STORM WATER MANAGEMENT

Eglemont Development: The proposed storm water management plan presented in the SDA Technical Information Report (TIR) intercepts approximately 53% of the precipitation (the 146 dwellings of an average of 60% of 845,554 sqft, + the 315,173 sqft. of road surface) falling on the site. The South Basin (89% portion of the 35 acres) is routed through piping to the South Detention pond similar to Sinclair Heights (except it will not be retained by concrete). Where before development, a large portion of the precipitation was allowed to distribute over the site. Now that water is concentrated in the South Detention Pond. The SDA TIR pond design is equipped with an Emergency Overflow (EO) "bird cage" at the top of the pond's Frop T restrictor, where the EO is allowed to settle and then flow into an open ditch (with biofiltration elements) and onto a level Spreader into Sinclair Heights Tract 998, from whence it cascades to Sinclair Heights Tract 997, and onto Sinclair Heights Tract 996. (See Figures 998-1 - 998-7; 999-1 - 999-4; 996-1 - 2). No analysis (based on data from Sinclair Heights detention ponds) of the capacity of the Sinclair Heights wetlands to percolate

993-1

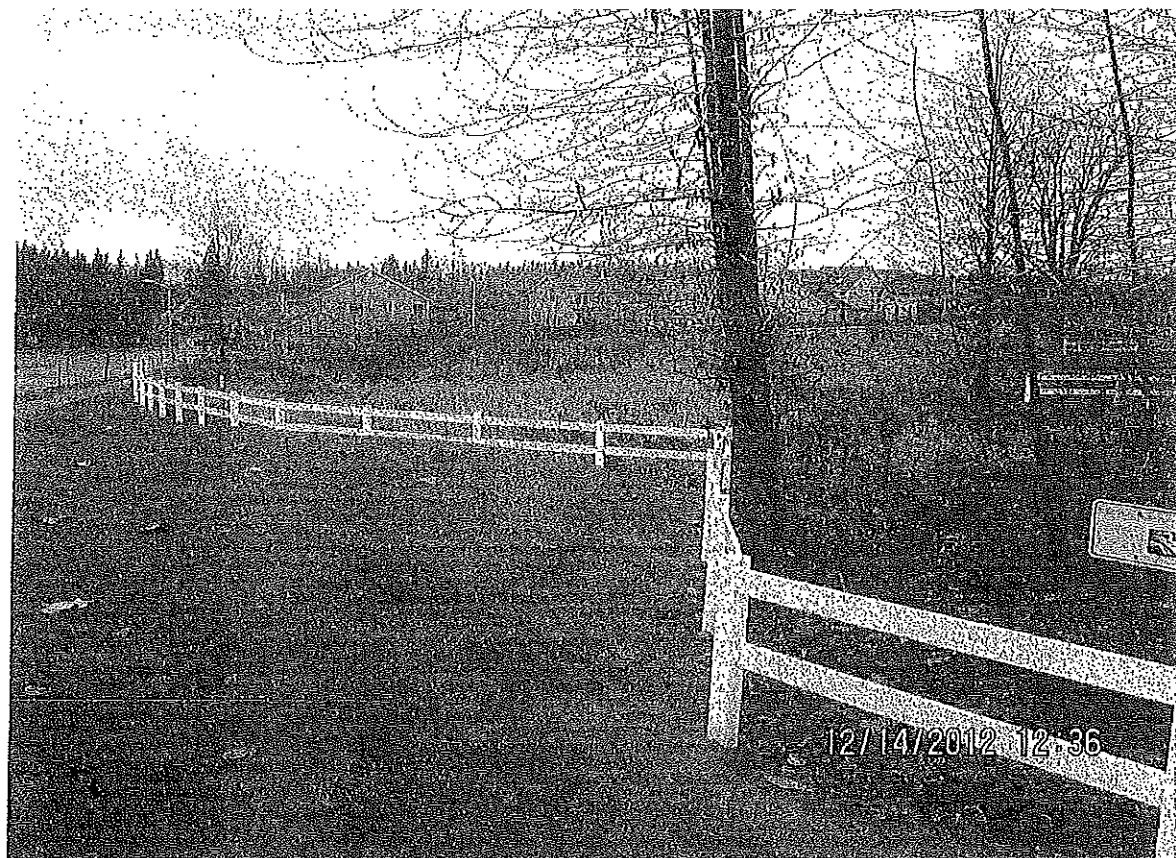
Sinclair Heights Background: The Heavy flow of South Snohomish County Convergence Zone precipitation has been routinely filling both Sinclair Heights detention ponds, Tracts 992 and 993 in the Fall and Spring. Figure 992-1,-2 , highlighted in white, shows the flow pattern at the inlet to the Emergency Overflow "bird cage"). Figure 993-1 shows the current remaining capacity in our second pond. The backyards and crawl spaces of our homes on the North side of Rainer View Road routinely pond precipitation in the Fall and Spring because the Vashon Lodgement, "hard pan" soil's density limits percolation beyond approximately 3 feet below the surface. The interceptor swales originally designed using weather statistics has been inadequate.

997-1

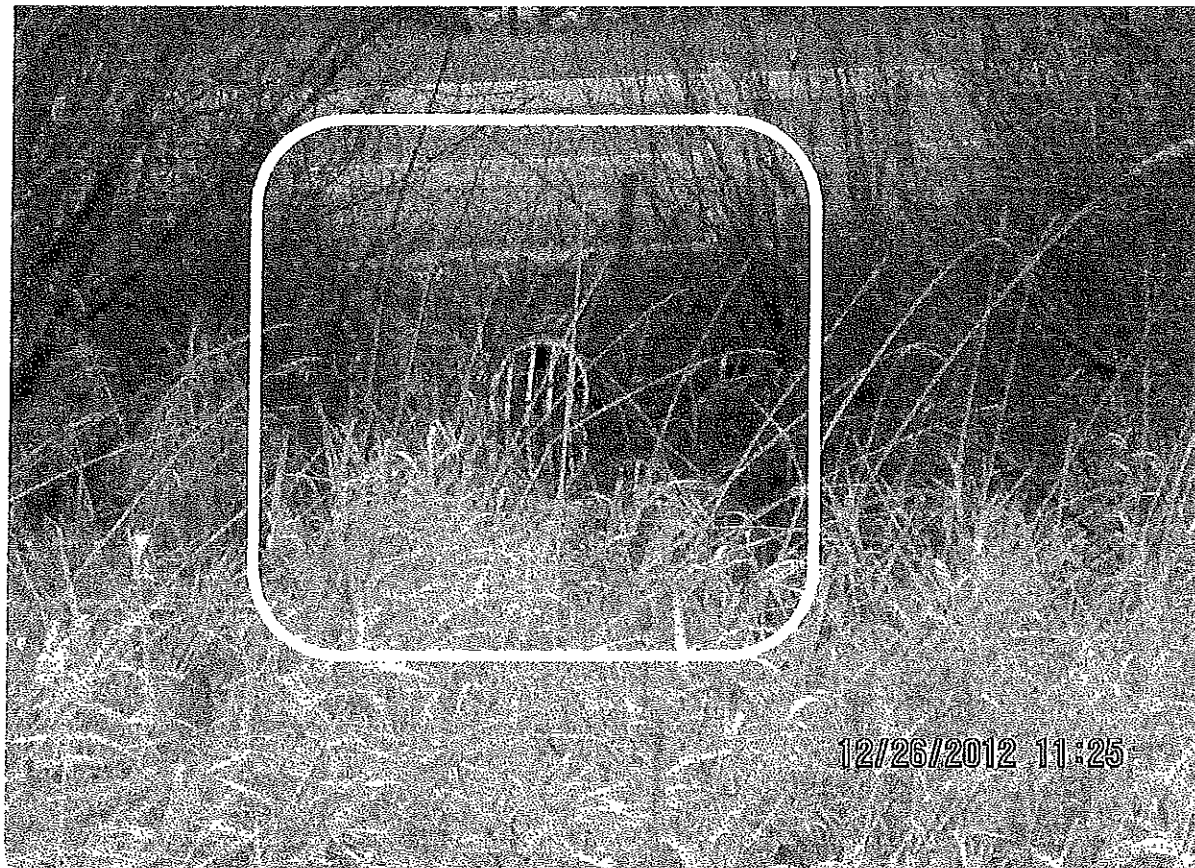
- 1) Pipe the Eglemont South Detention pond Emergency Overflow directly to Sinclair Heights Tract 997.
- 2) Add an Emergency Overflow Pipe at the outlet of Sinclair Heights Tract 997 directly to Sinclair Heights Tract 996.
- 3) Add an Emergency Overflow Pipe at the outlet of Sinclair Heights Tract 996 directly under the Sinclair Heights bike/walkway.

RV2CL-2

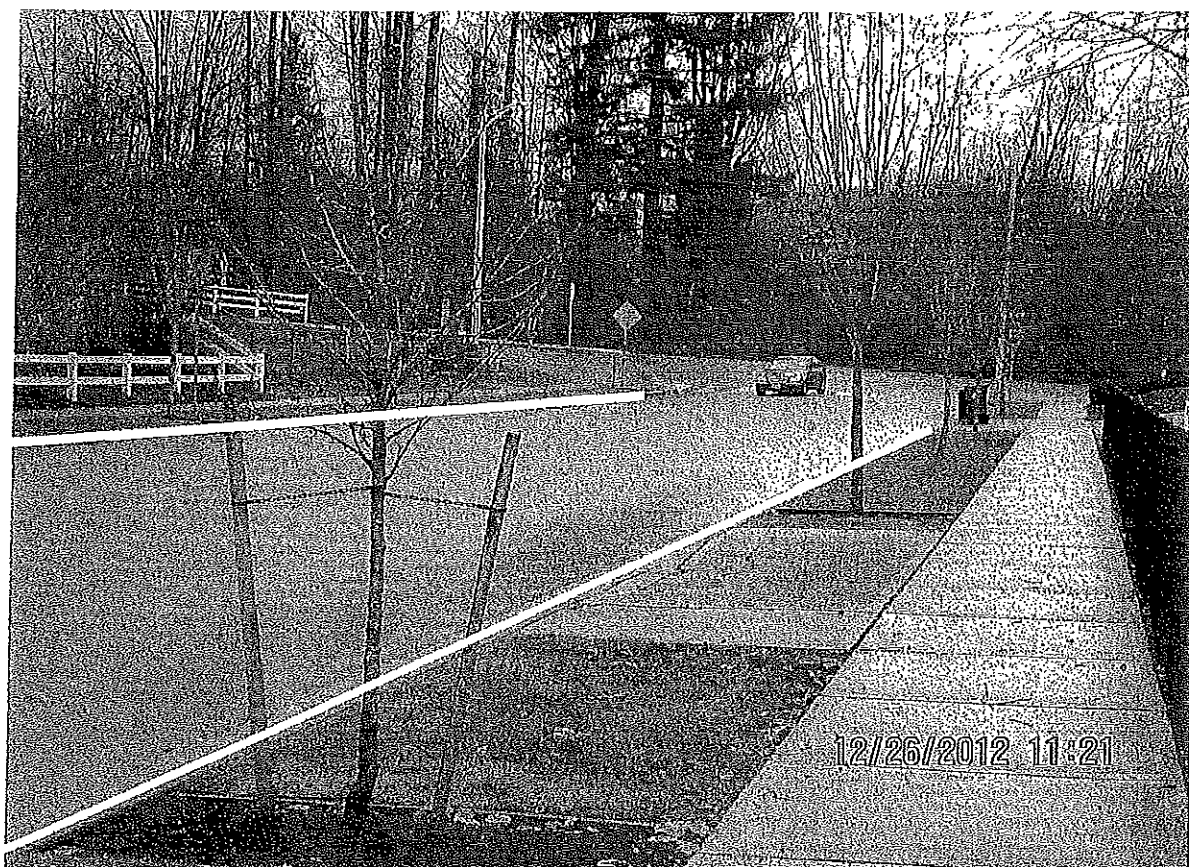
Rainier View Road Traffic Accident Prediction: During Eaglemont Phase One construction, extra long double dump, Bulldozer/Excavator Trailer, Cement, and home material trucks will collide with parked cars, and block access during their “S” maneuver (see figure RV2CL-1,-2). During Eaglemont Phase One construction, the mixture of heavy trucks and park pedestrians at the uncontrolled intersection will lead to injury (see figure RV2CL-3)

Mitigation of Rainier View Road congestion: Complete the North access road to Eaglemont and require construction equipment use the North access as the primary access for construction. Install signal controls at Rainier View Road and Chain Lake Road intersection. The \$304,407 fee noted in pg 14 is probably not enough.
